Subject: Inclusion of pipes using vibration
process in IS 458

AMENDMENT NO. 4 MARCH 2003
TO
IS 458 : 1988 SPECIFICATION FOR PRECAST
CONCRETE PIPES (WITH AND WITHOUT
REINFORCEMENT)
(Third Revision)

AMENDMENT NO. 3 SEPTEMBER 2001
TO
IS 458:1988 SPECIFICATION FOR PRECAST CONCRETE PIPES
(WITH AND WITHOUT REINFORCEMENT)

AMENDMENT NO. 2 APRIL 1991
TO
IS 458:1988 SPECIFICATION FOR PRECAST CONCRETE
PIPES (WITH AND WITHOUT REINFORCEMENT)
(Third Revision)

Table 10A Spigot and Socket Dimensions for NP3 Reinforced and Unreinforced and NP4 Reinforced Pipes Made by Vertical Casting Process

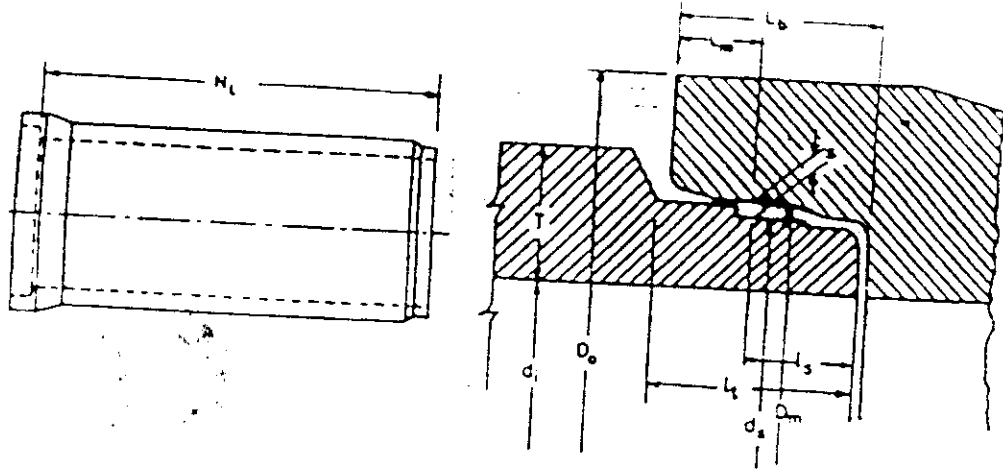
(Page 14, Table 10) — Insert the following new Tables 10A and 10B after Table 10:

FIG. 5 PERMEABILITY TEST

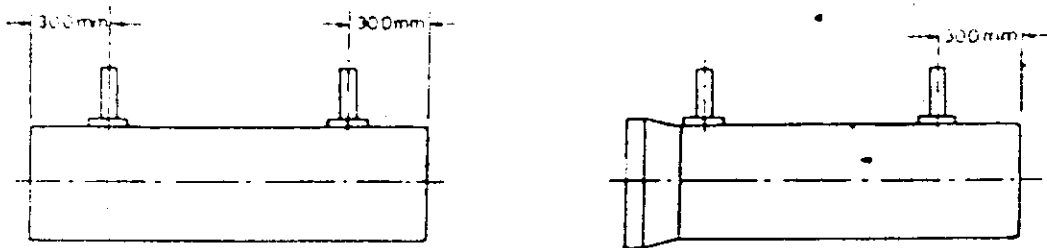
[Page 21, Fig. 5 (see Amendment No. 3)] — Delete.

(Page 21, clauses 9.2.1 and 9.2.2) — Substitute the following for the existing clauses :

9.2.1 Permeability test when conducted in accordance with the method described in IS 3597 : 1998, shall satisfy the following requirements. The tests shall be done on outside surface of pipe at two places as shown in Fig. 5.

9.2.1.1 Initial absorption

The drop of water level in the stand pipe at the end of 2 h is the initial absorption. This shall not exceed 1.5 cm and the difference in any two readings shall not be more than 0.5 cm³.

9.2.1.2 Final permeability

Fill the water in the stand pipe again up to the mark and take readings at half-hour interval up to 4 h. Absorption in the fourth hour is the final permeability. The average reading of two tests conducted on a pipe shall be expressed in cm³ and this shall not exceed 0.3 cm³.
